SERVICE LETTER

No. 819A

Piper Aircraft Corporation

Air-Conditioning Compressor Drive Belt
Alignment Procedure

SKETCH B

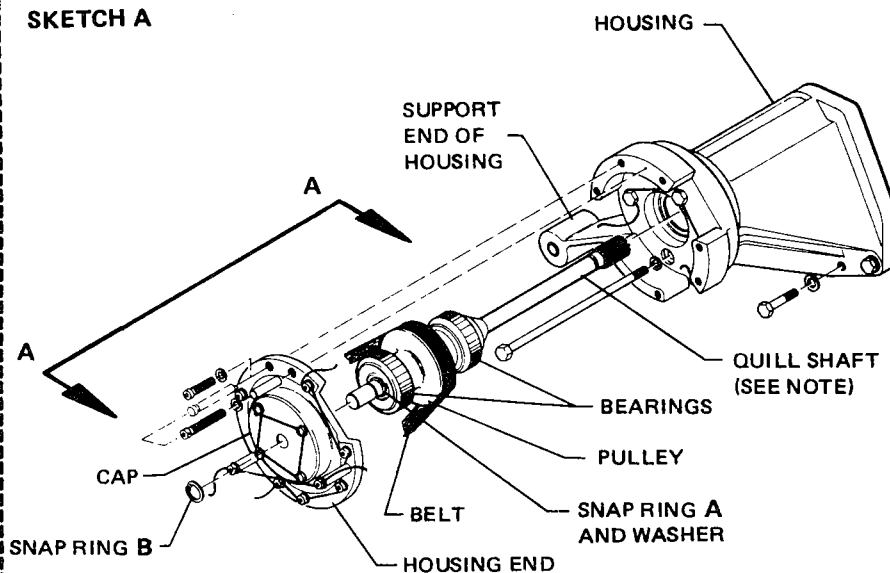
- k. Inspect the ball bearings for flat spots by slowly rotating the bearings, if found defective, replace the bearings.
 - l. If the shaft is in good condition, but the end play is more than .005, and/or the snap rings or grooves are deformed it will be necessary to re-machine the snap ring groove and install a Walds Kohinoor Snap Ring No. 5160-47 per the following instructions: (Refer to Sketch B.)

1. Measure dimension (C) which is the distance from the outer faces of both bearings.
 2. Measure thickness of washer used with inner snap ring (A).
 3. Re-machine snap ring groove (A) so that the forward edge of groove (A) on dimension (D) equals dimension (C) plus the washer thickness (+.005/-.000). Groove dimensions are as follows: .442/.445 minor dia. and .046/.049 width.

4. If the snap ring groove (B) is damaged, re-machine it to accept the heavier snap ring, holding dimension (E) at $2.729 + .010/-0.000$ of an inch.
 - m. Clean any paint from the cap and housing mating surface.

SKETCH C

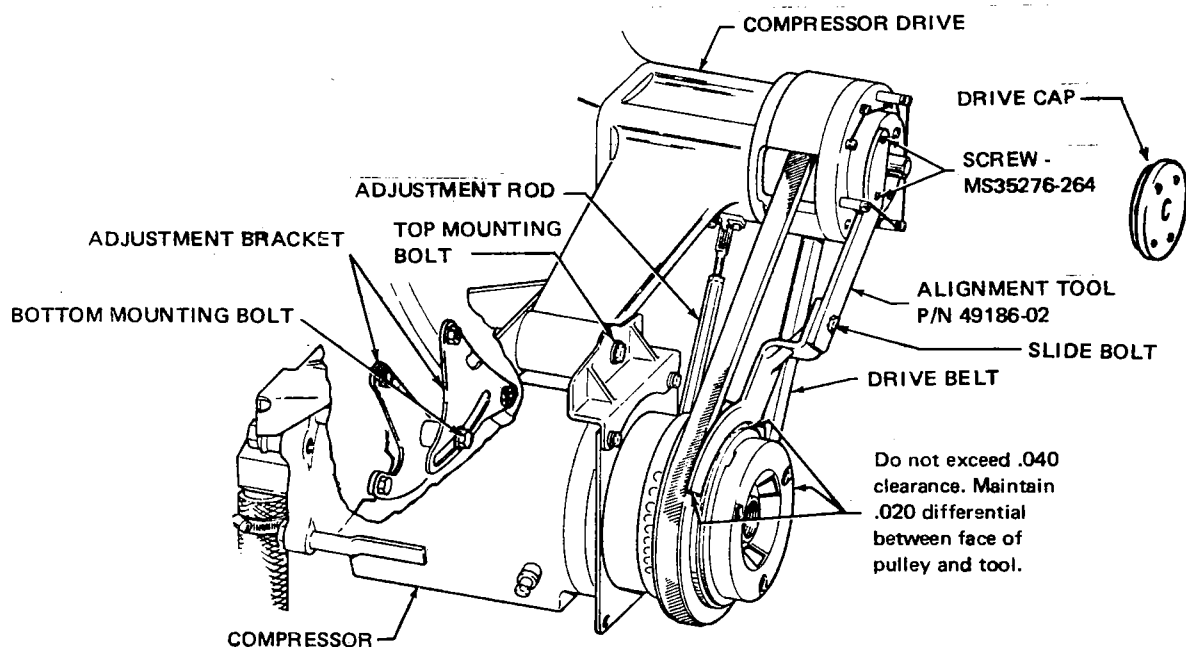
Revised belt alignment procedure, ref. attached
sketch/instruction data, items q.1. and r;
revised Sketch "C"

- p. When the bearings are replaced in new housing, Loctite "E" should be used on the outer surface of the bearing only.
 - q. With the drive unit assembled in accordance with service manual and the belt installed, proceed to check belt alignment as follows: (Refer to Sketch C.)

1. Remove the compressor drive cap and attachment screws as shown in Sketch C. Retain screws and washers.
 2. Attach the alignment tool P/N 49186-02 to the compressor drive by using two MS35276-264 screws.

3. Tighten the attaching screws, making certain the tool is clear of all obstructions and lightly tighten the slip nut and bolt on the tool.
 4. Tighten the compressor drive belt by pulling the compressor by hand.

5. While maintaining belt tension tighten the bottom attachment bolt.
 6. Reattach the adjustment rod to the compressor and adjust to achieve the proper belt tension (Use a tensiometer, such as a Gates Rubber Co., 150.) (Refer to Table) and pulley alignment.

When acquiring belt tension, maintain even clearance between the face of the compressor pulley and alignment tool.

7. Tighten the top mounting bolt on the compressor.
8. Should it be necessary to align the pulleys forward or aft to achieve alignment, the support end of the housing can be milled up to .09 of an inch on either side and an aluminum or steel shim washer used to adjust the compressor position.
- r. With the alignment completed, remove the alignment tool and reinstall the drive cap with original screws and washers. Safety wire the screws.
- s. Reinstall the engine cowlings.
